# Port Hope File Factory

A plea for taking more care

Philip Goldsmith | Architect

29th October 2023  
Philip Goldsmith

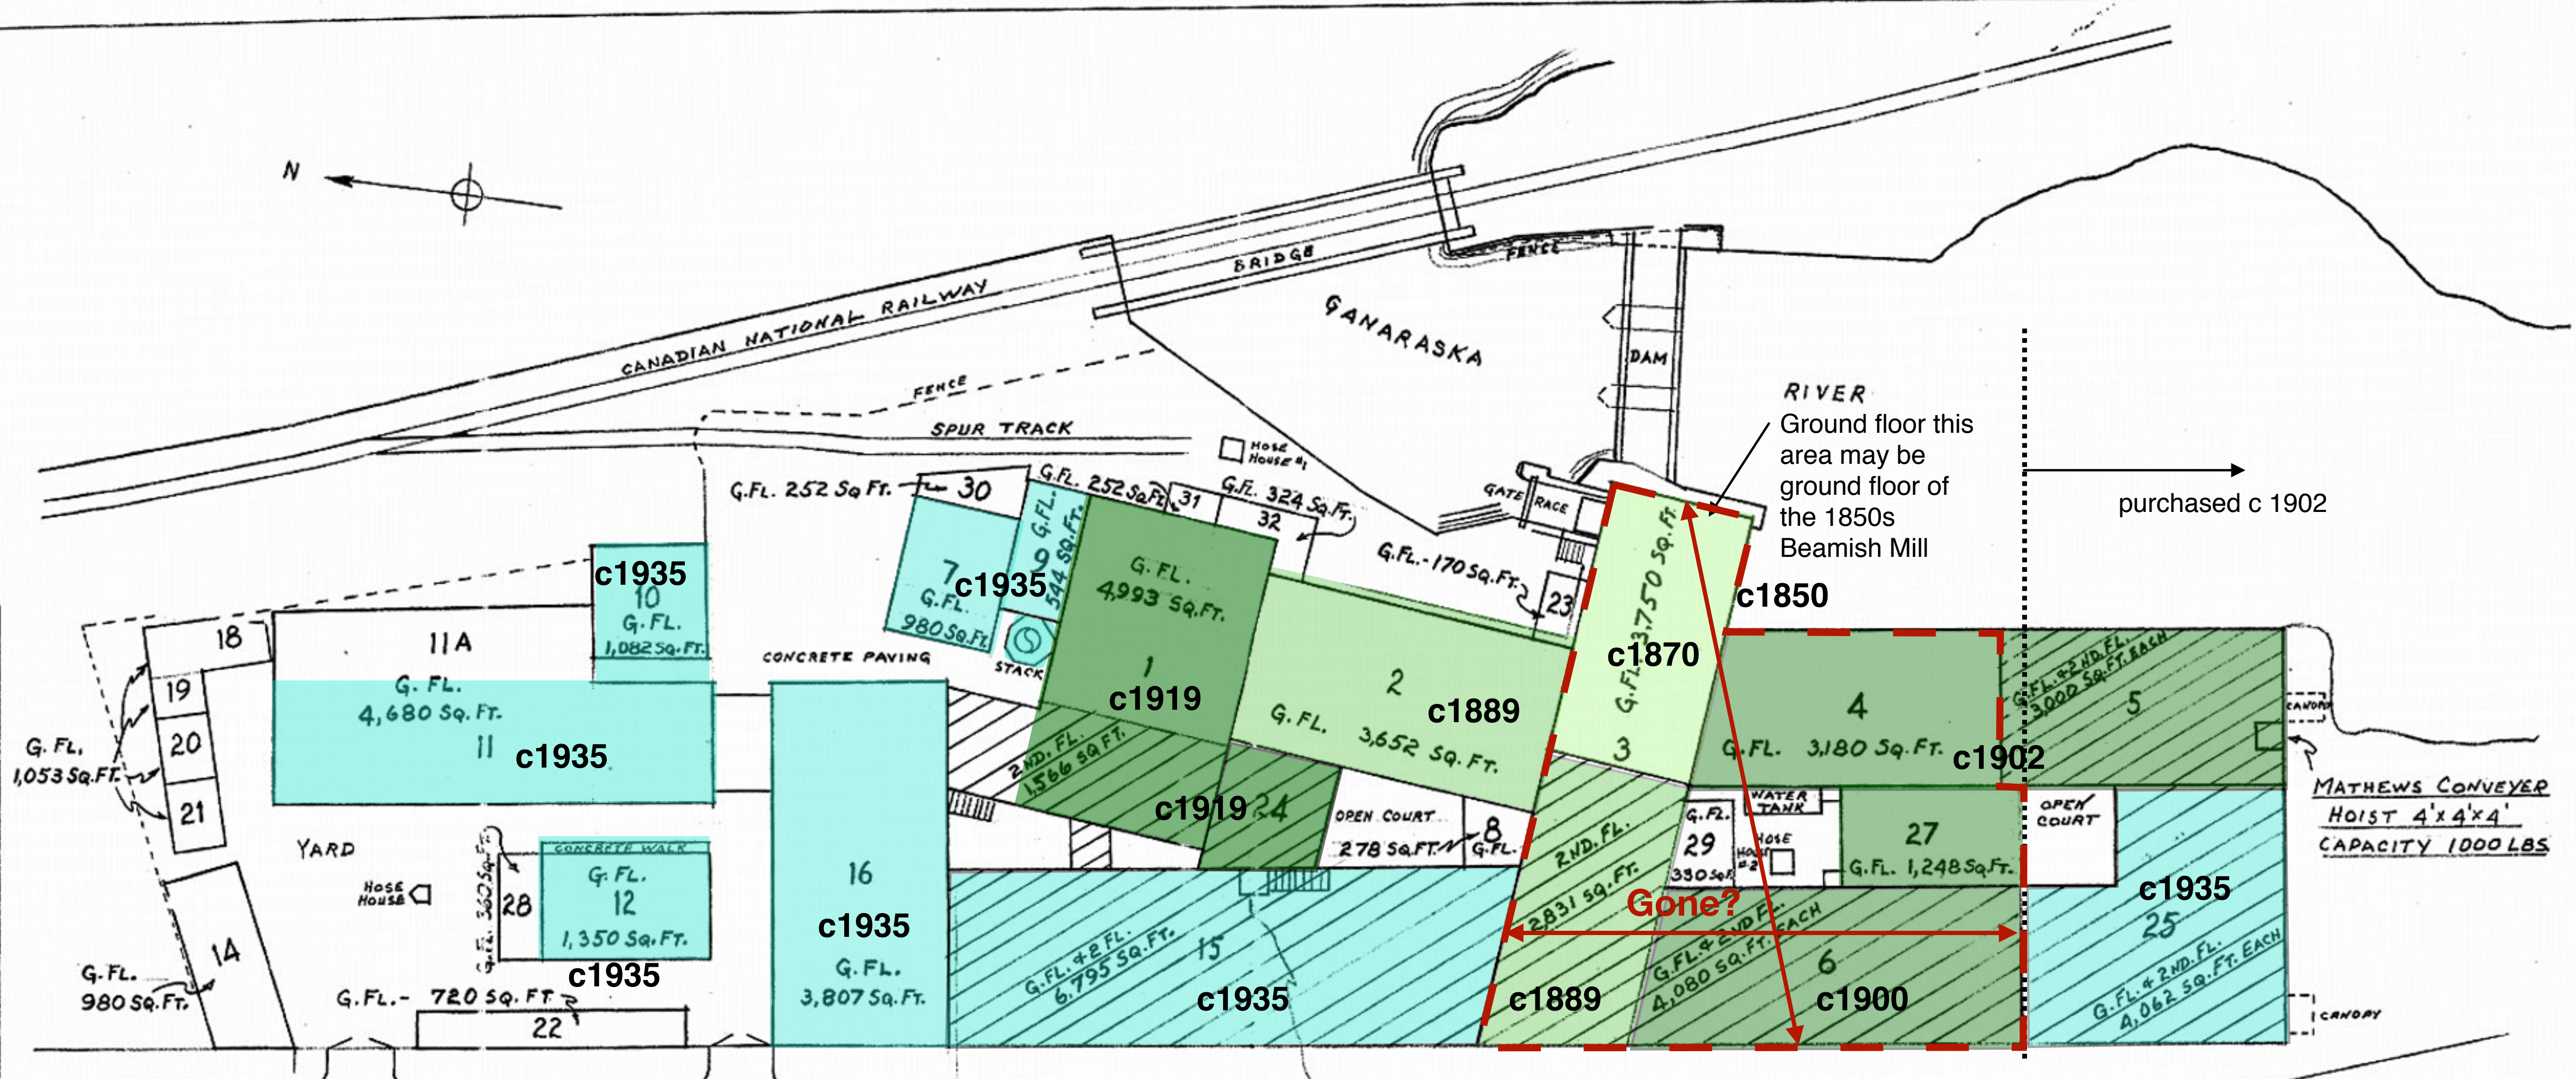
Exterior steel hoist structure, preserve on site

1935, encourage reuse of structure, could be altered to suite new purpose

1919 building, east elevation overlooking river is significant public facade, encourage reuse of some or all of remainder

1889 building, east elevation and roof form overlooking river is significant public facade, encourage reuse of some or all of remainder

1850-1889, East elevation overlooking river, ground floor stone and brick walls incorporating part walls from original 1850s mill, window openings with multi lite windows, side wall returns to buildings 2 and 4. (encourage preservation of associated mill race and remnant dam structures and interior wood heavy timber structure, remand of 1850s mill)

**Condition Overview - F1**

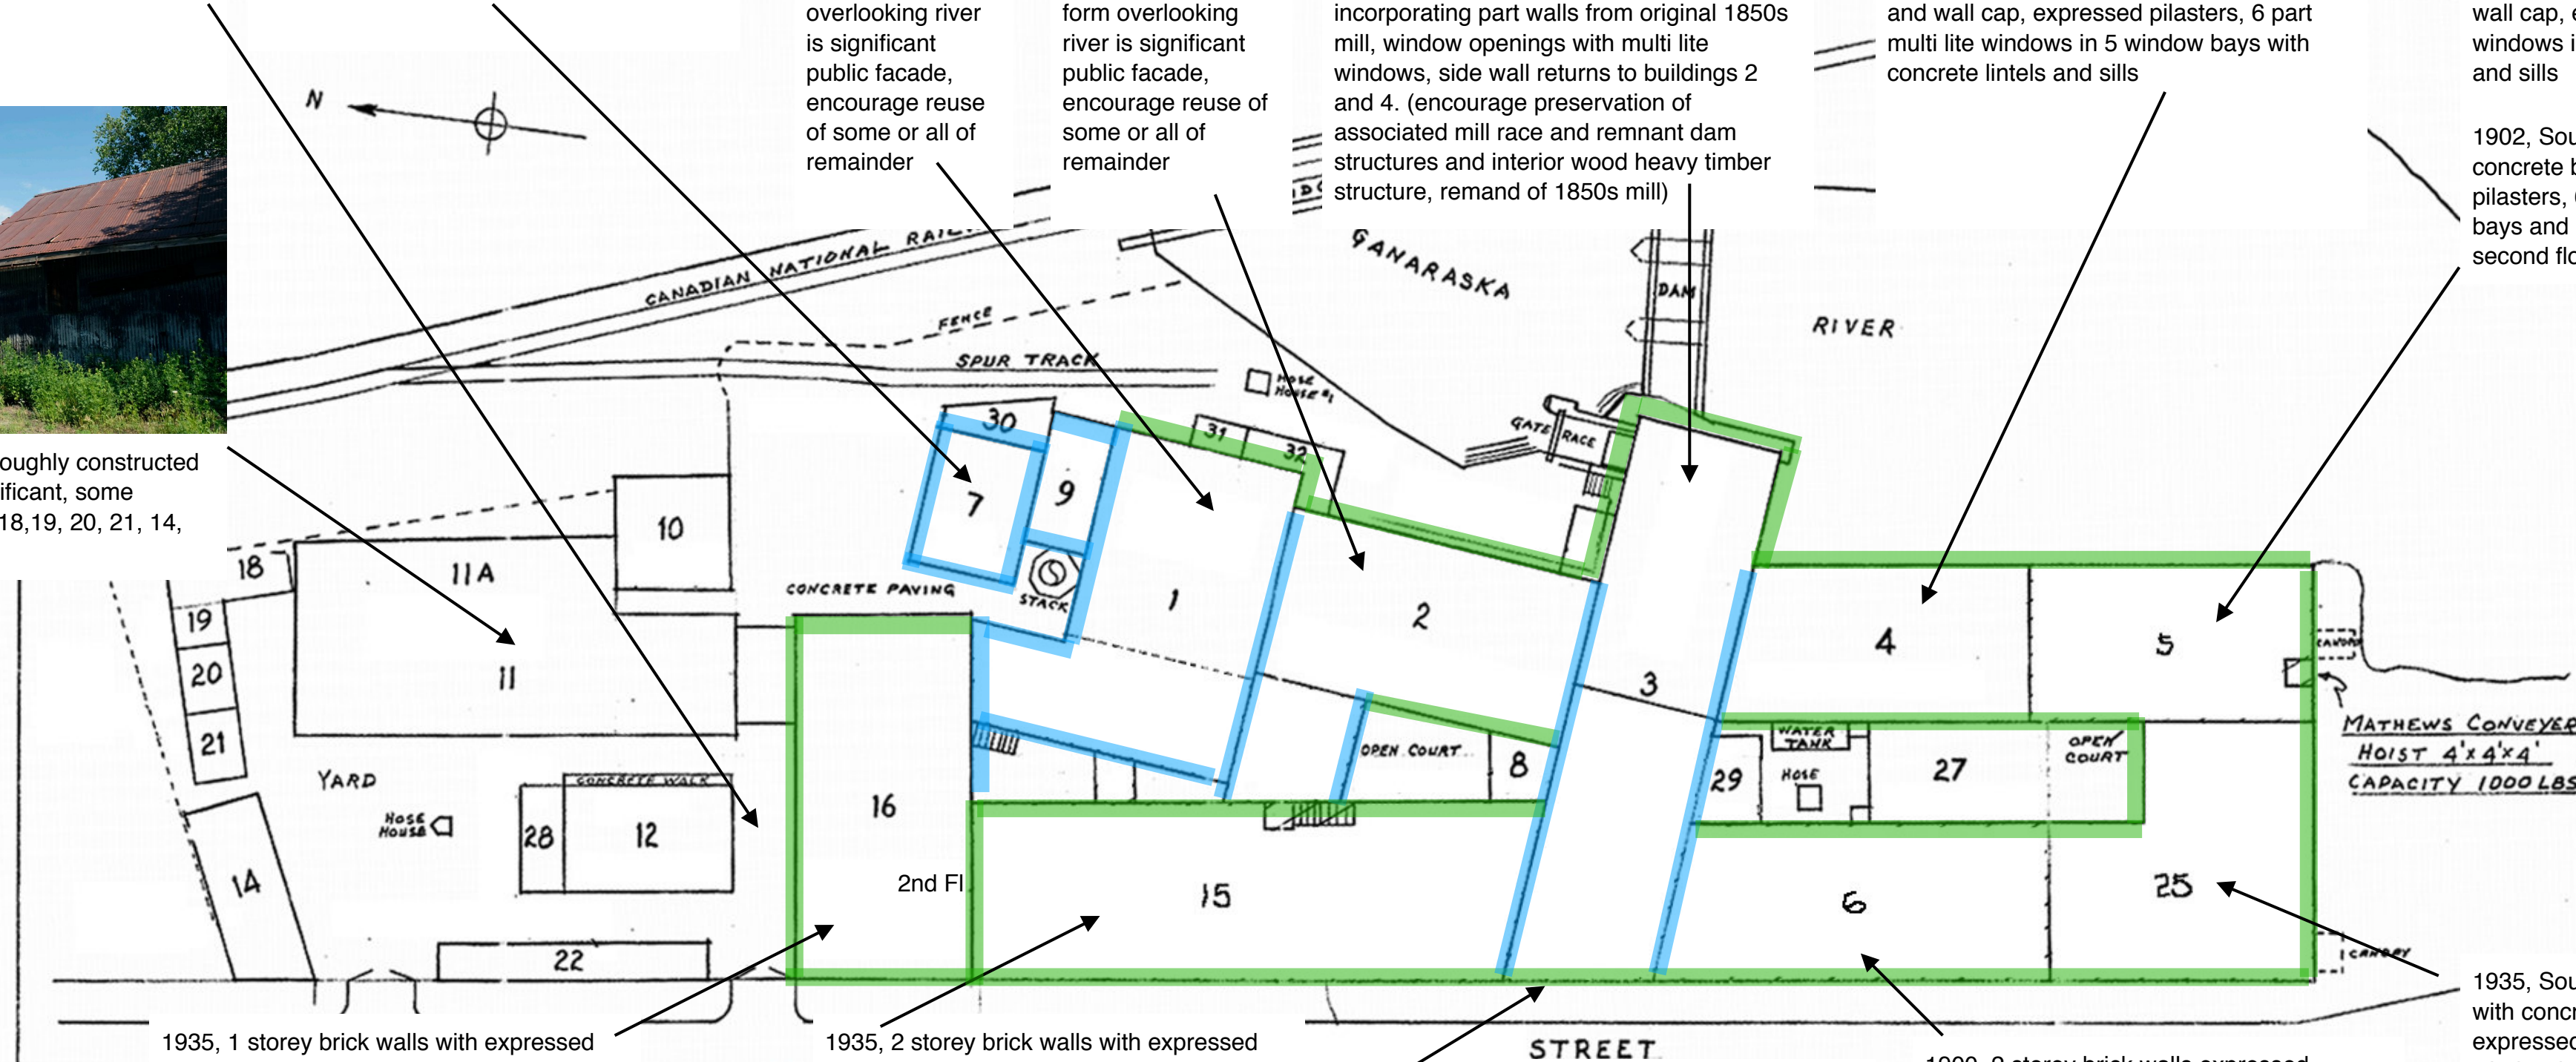
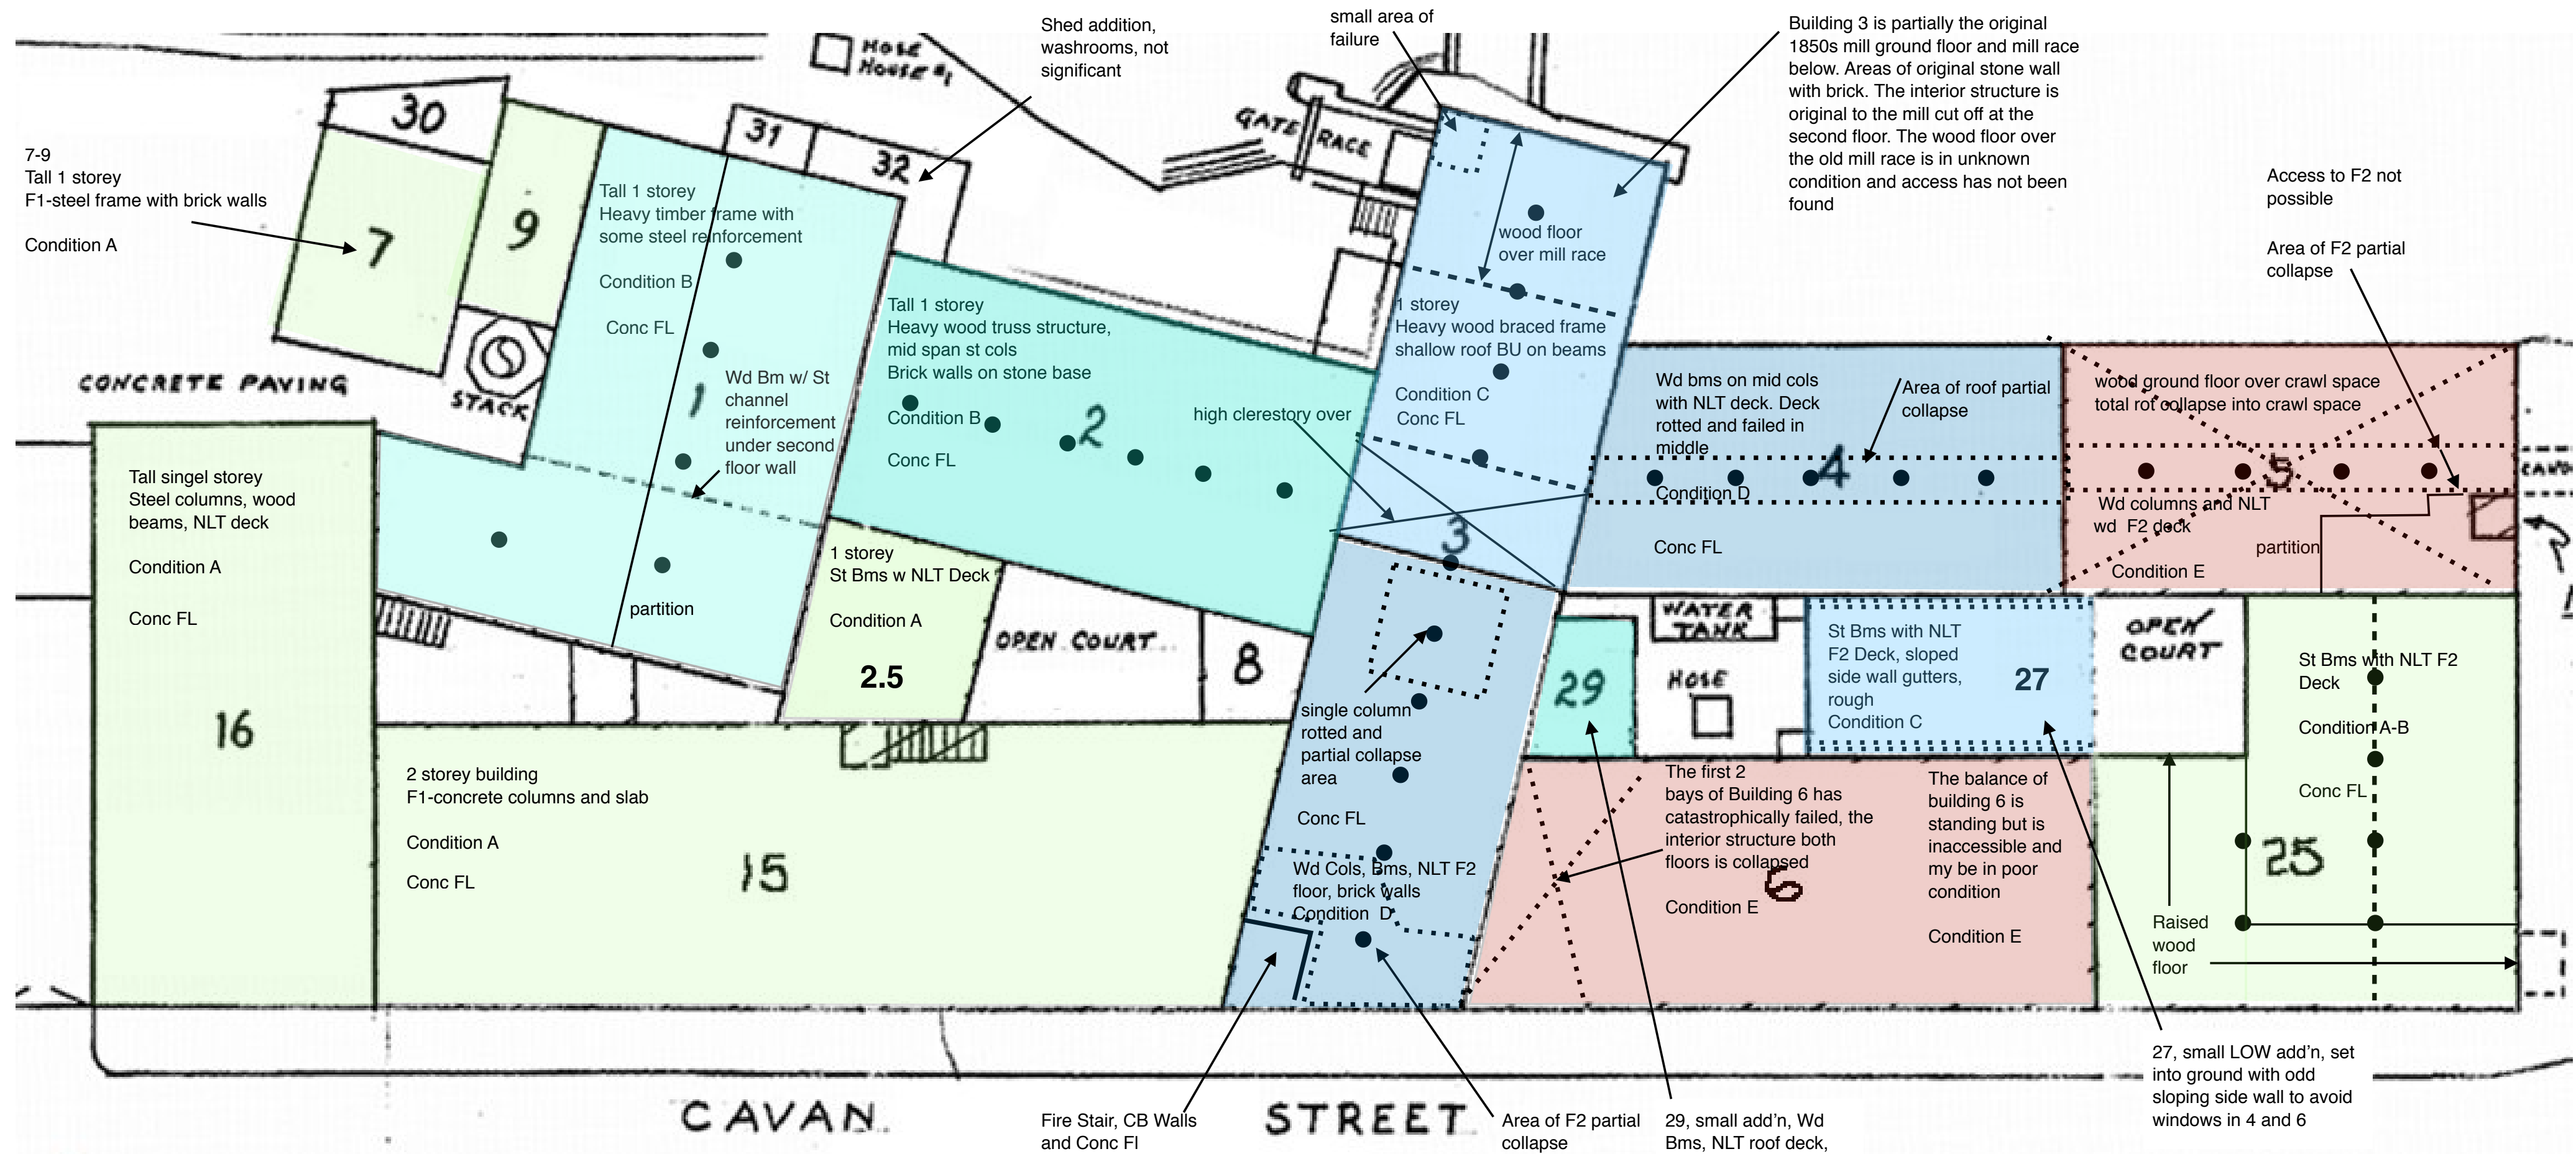
1902, East elevation overlooking river, 1 storey brick walls with concrete banding and wall cap, expressed pilasters, 6 part multi lite windows in 5 window bays with concrete lintels and sills

1902, East elevation overlooking river, 2 storey brick walls with concrete banding and wall cap, expressed pilasters, 6 part multi lite windows in 5 window bays with concrete lintels and sills

1935, (10, 11) 1 storey roughly constructed shed structures not significant, some previously demolished (18,19, 20, 21, 14, 22, 28, 12)

1935, 1 storey brick walls with expressed concrete pilasters with stepped brick capitals, full width window openings with concrete lintels and sills, large multi lite windows. North Elevation returning to east elevation with same attributes

1935, 2 storey brick walls with expressed concrete pilasters with decorative Deco capitals, full width window openings at ground and second floor with concrete lintels and sills, large multi lite windows. North Elevation returning above #16 with same attributes

1889, 2 storey brick walls expressed pilasters, paired second floor windows with brick arched openings (ground floor altered several times, encourage some restoration at ground floor)

1900, 2 storey brick walls expressed pilasters denticulated step below parapet forming pilaster bays, paired ground and second floor windows with brick arched openings ( encourage restoration of altered ground floor openings)

1935, South elevation, 2 storey brick walls with concrete banding and wall cap, expressed pilasters, multi lite windows in 4 window bays

West elevation, 2 storey brick walls with concrete banding and wall cap, expressed pilasters, multi lite windows in 5 window bays
